ASSESSMENT REPORT

Section 75W Modification

Trinity Point Mixed Use Development, Trinity Point Road, Morisset Park, Lake Macquarie Local Government Area MP 06_0309 MOD 5

Figure 18: Comparison of Approved and Proposed Development from Vantage Point 1

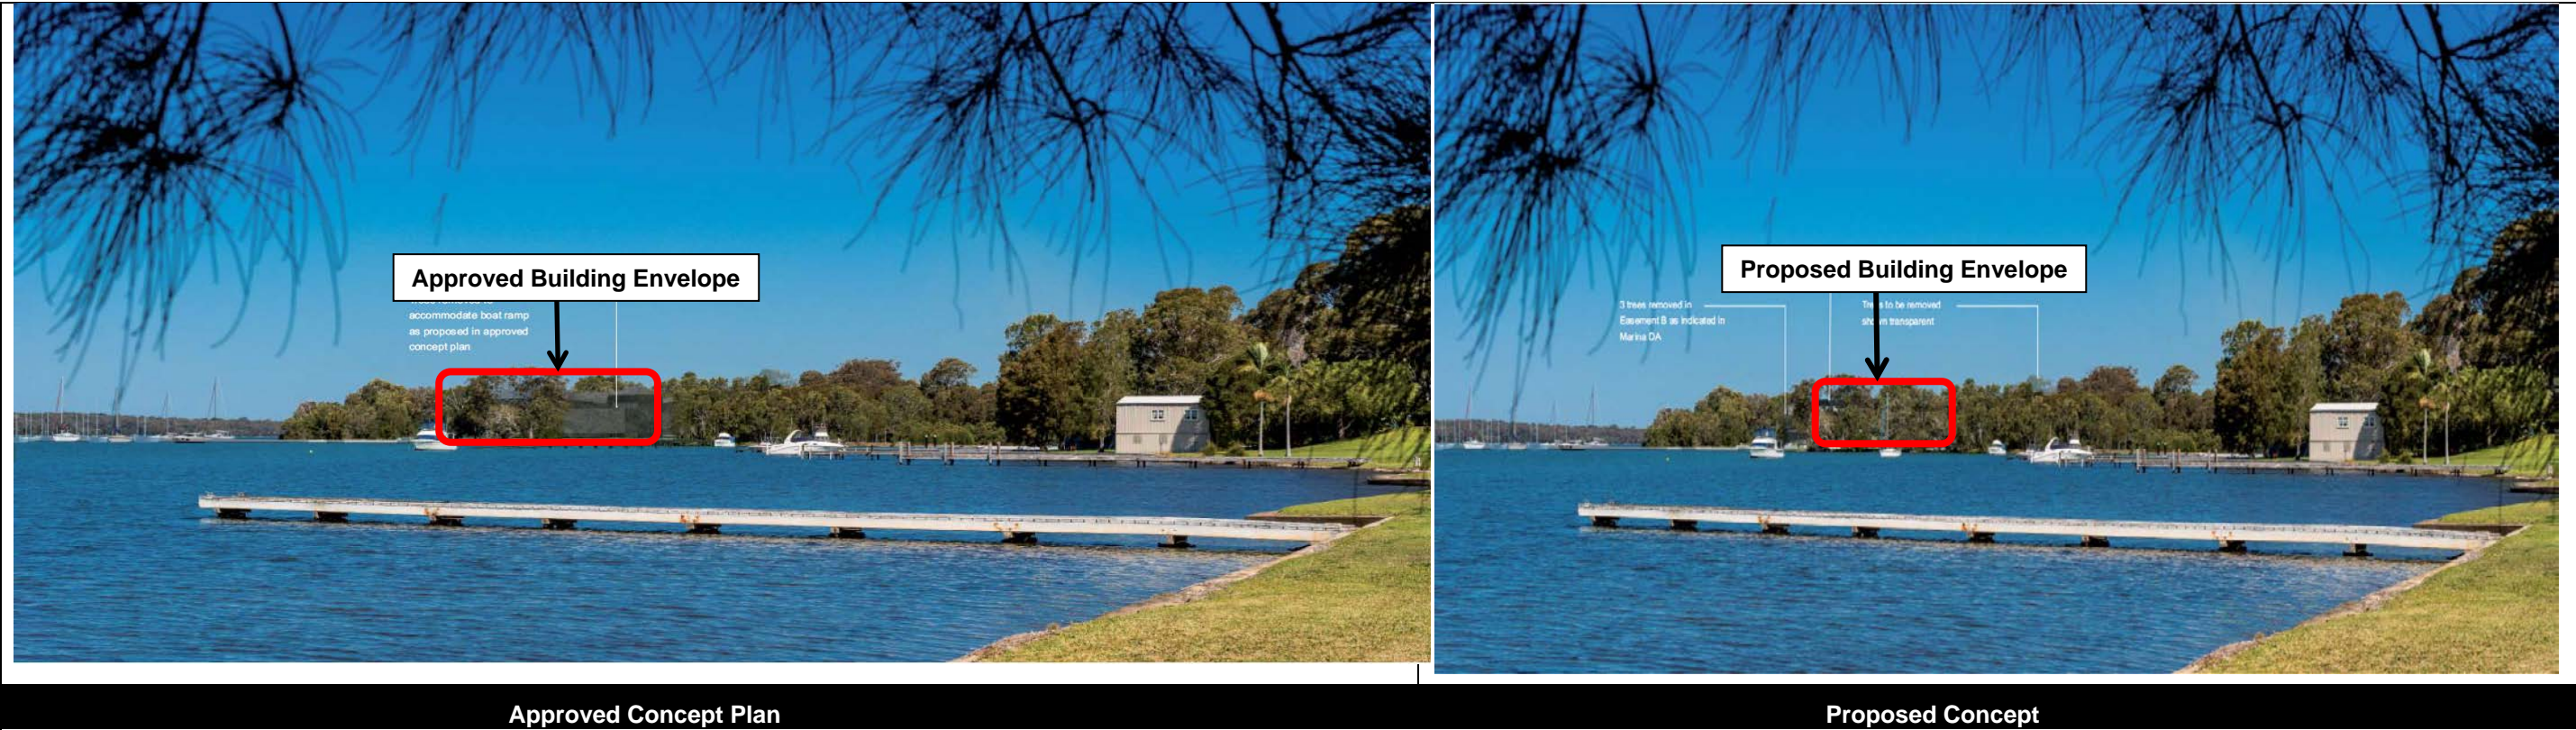
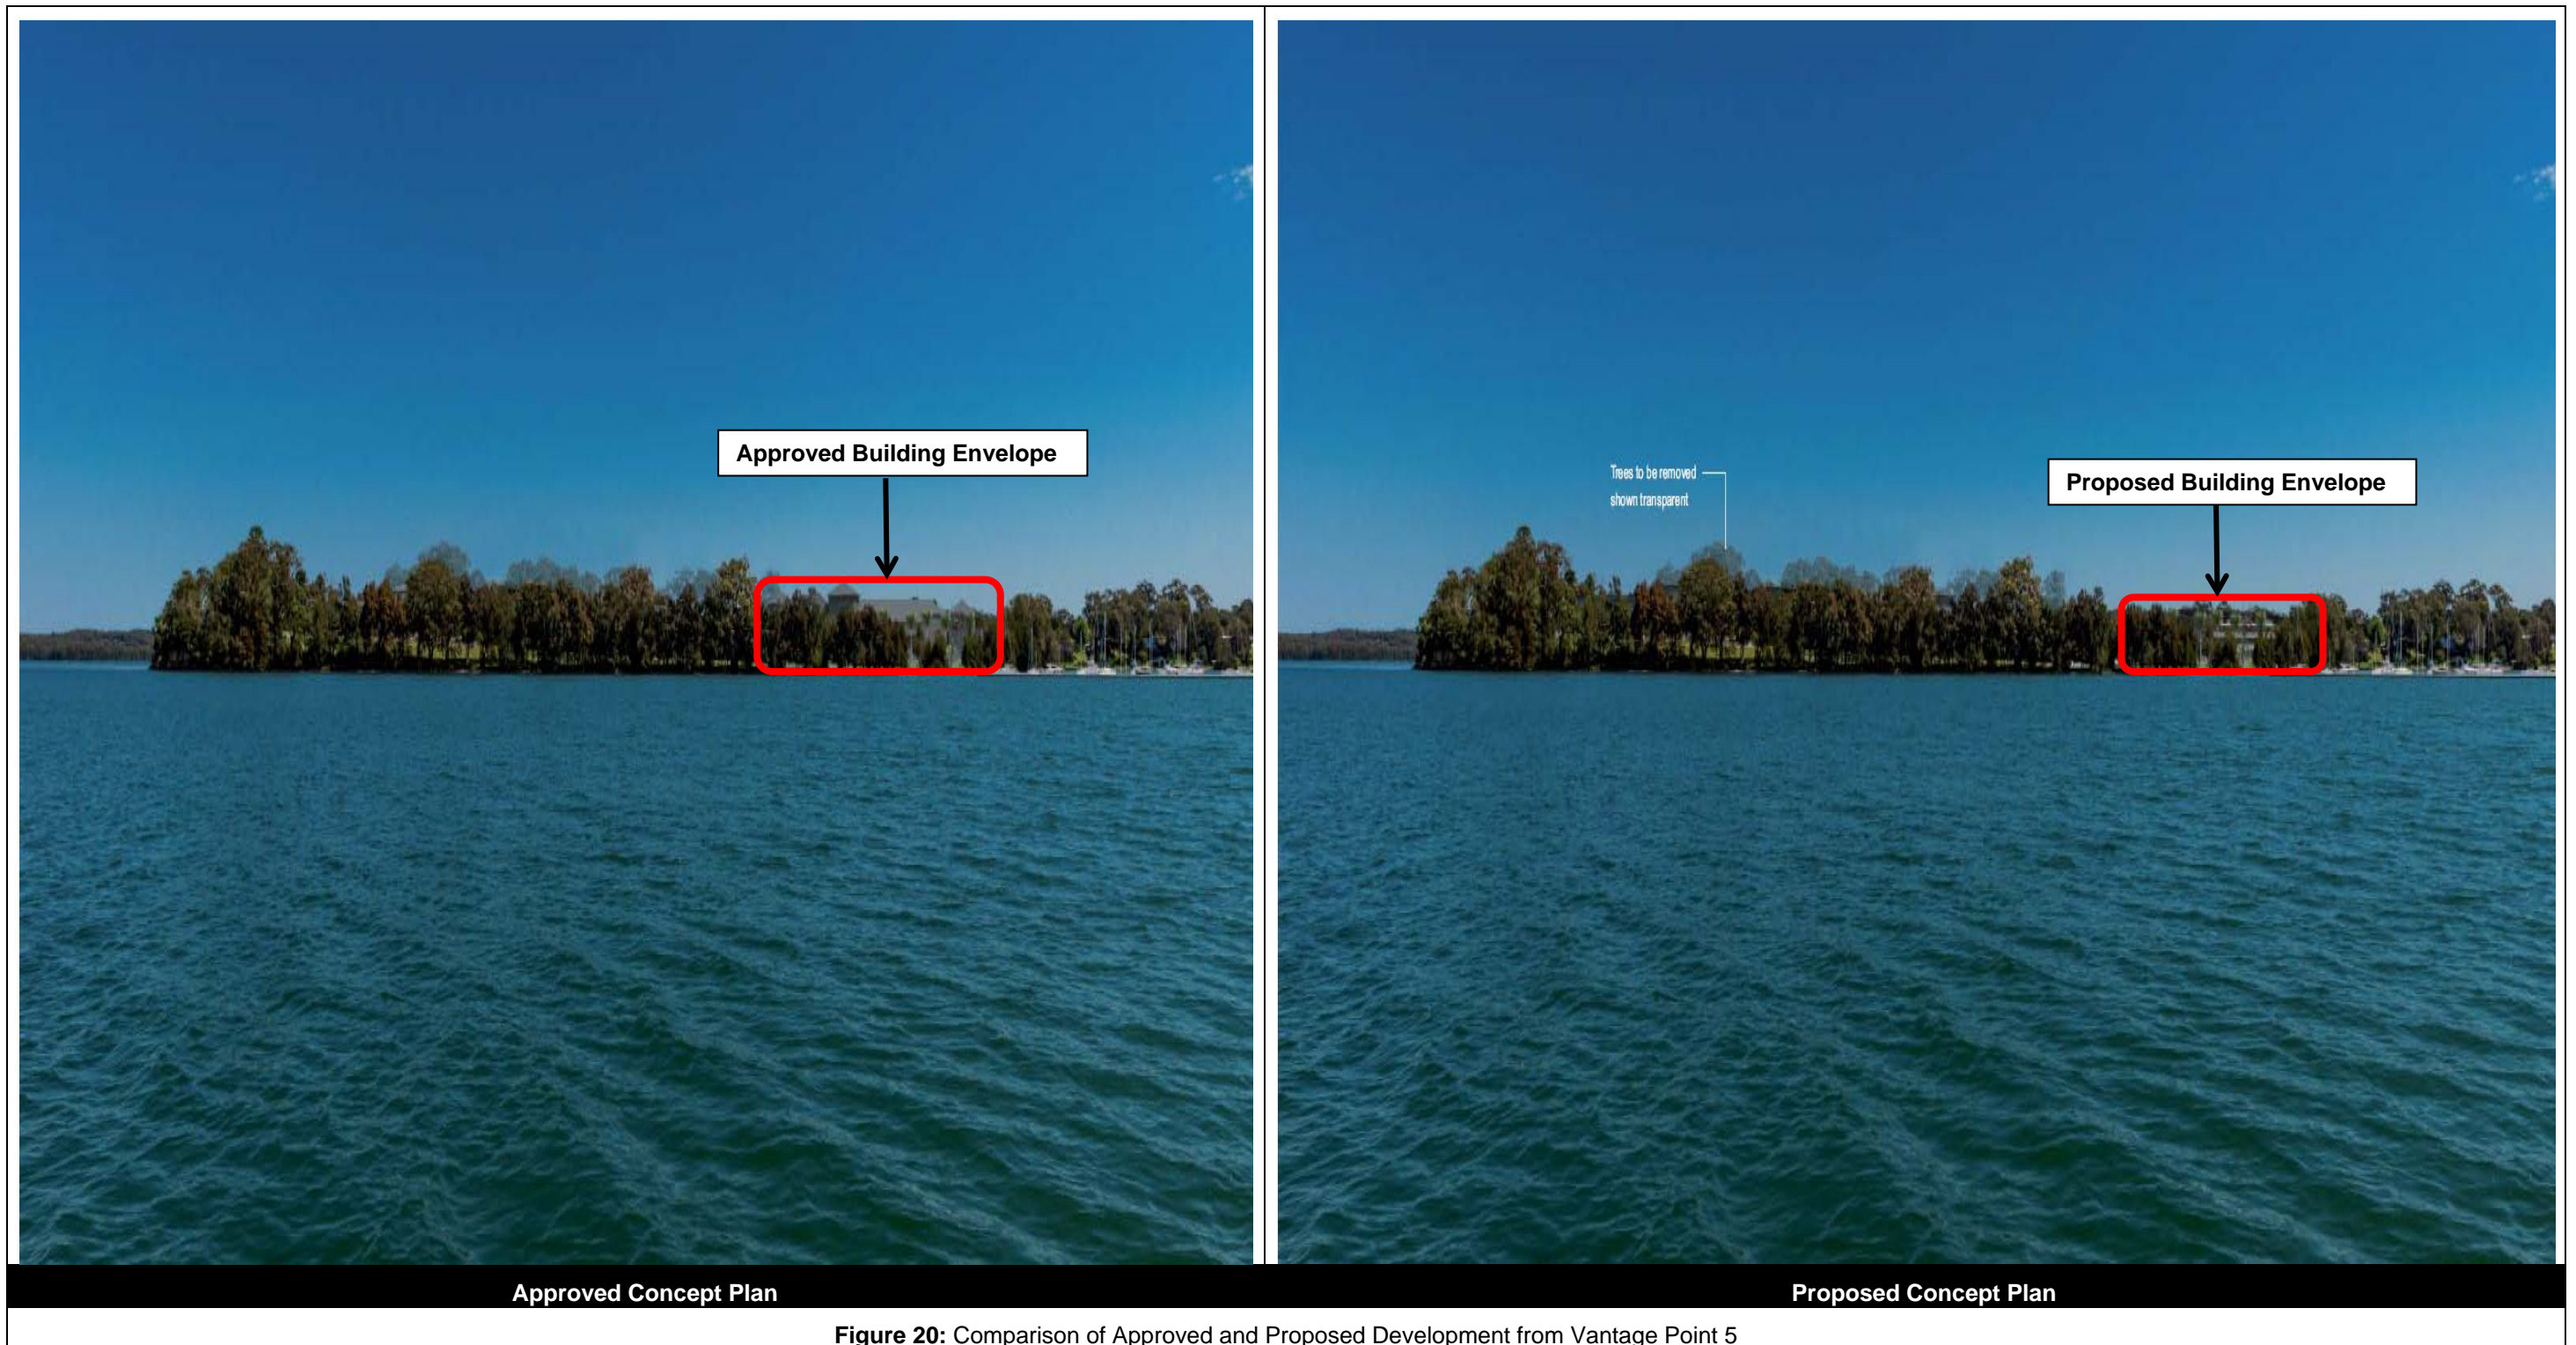
- the existing tree canopy within the foreshore reserve will remain as the prevailing visual element consistent with the approved Concept Plan when viewed from vantage points 1, 3 and 5, and as such the proposed modification would not result in any significant view blocking within the public domain in comparison to the approved Concept Plan (see **Figures 18 to 20**);

Figure 21: Proposed Building Envelope Separation Distances

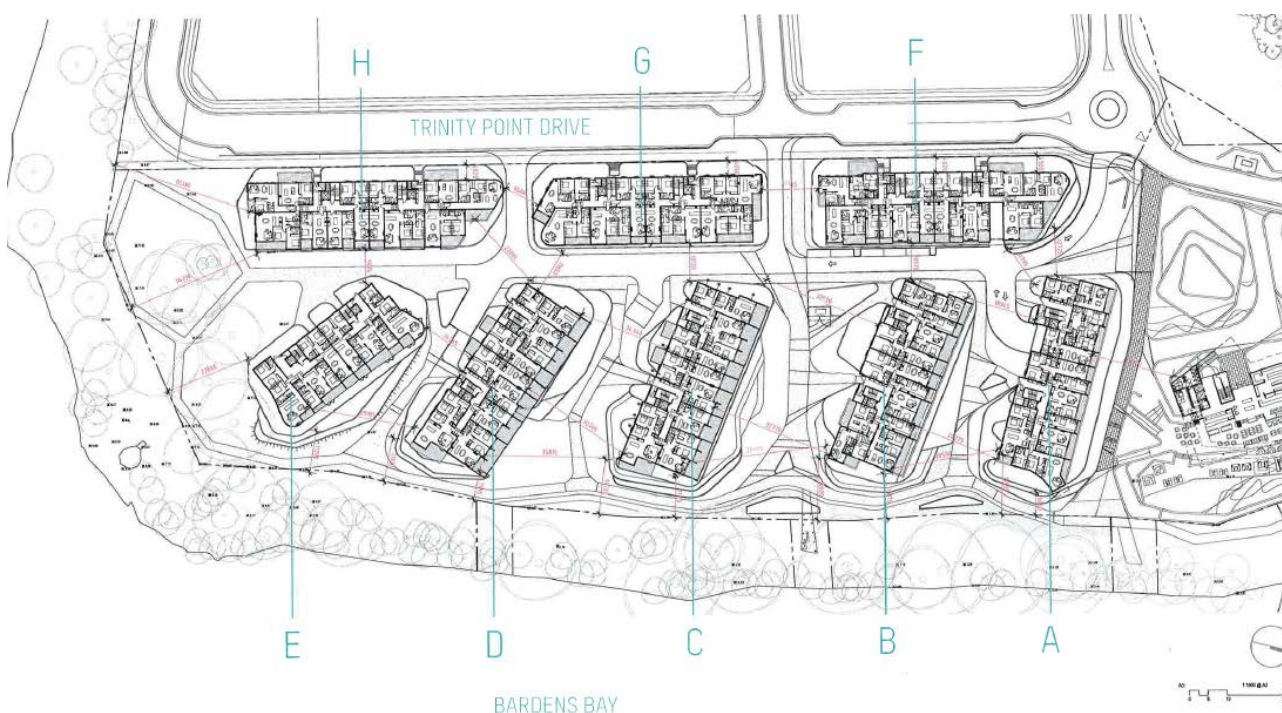
The majority of the building envelopes achieve the 12 m separation distance. In addition, the proposed envelopes generally achieve greater building separation distances in comparison to the approved Concept Plan (separation distances of between 8 m and 15 m approved). However, the separation between the building envelopes for proposed future buildings F & B, F & A, G & C, G & D, H & E and G & H have separation distances ranging between 8 m and 10.5 m (see **Figure 21** below).

The Department has reviewed the siting of the proposed building envelopes and has concluded that a separation distance of 12 m or greater is generally provided, and where building separation is less than 12 m, future development applications can be designed to comply with the requirements of the RFDC and the *Apartment Design Guide* by offsetting windows and balconies, or by incorporating appropriate screening. The Department is satisfied that the existing terms of approval (Term 3)
